SERVICE BULLETIN

NUMBER: DCI-BH430-IBF-SB01
Date: 13 July 2021

SUBJECT: BACKSHELL FASTENER REPLACEMENT

Bell Helicopter - Model: 430 (STC SR02794CH) (SN 0001 & SUBSQ)

Figure 1 – Location of Backshell Screws Recommended for Replacement

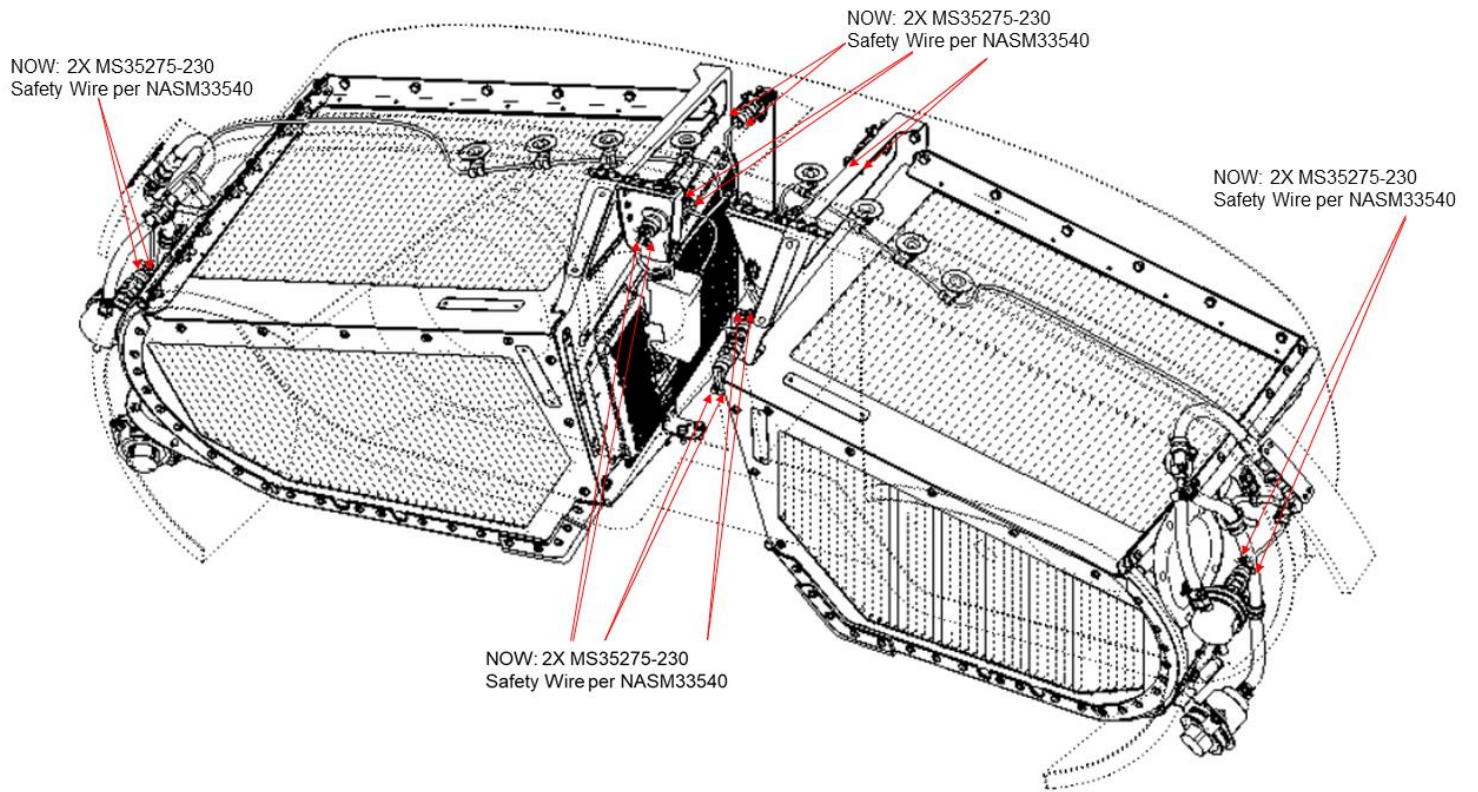
This is not a safety of flight issue, if operators follow Section 8.5.5 of the Instructions for Continued Airworthiness (ICA) and verify that Backshells are secure during regular maintenance intervals, then it is highly unlikely that the Backshell fasteners will come loose during flight. Nonetheless, Donaldson recommends a product improvement for all operators of the DCI Bell 430 IBF by replacing the existing fasteners on the Backshell of the 118400-101 Wire Harness connecting to the linear actuator & the Backshell of the linear actuator (118113-203) with MS35275-230 screws and to safety wire the screws per NASM33540. Location of these screws can be found depicted in Figures 1 and 2. Inspection requirements for the Backshells will remain the same unless otherwise directed by a newer revision of the ICA (Reference 1).

Operators are recommended to locally procure the replacement hardware as applicable. If local procurement is not available, operators can procure the screws from Donaldson's ecommerce site found in the Contact section.
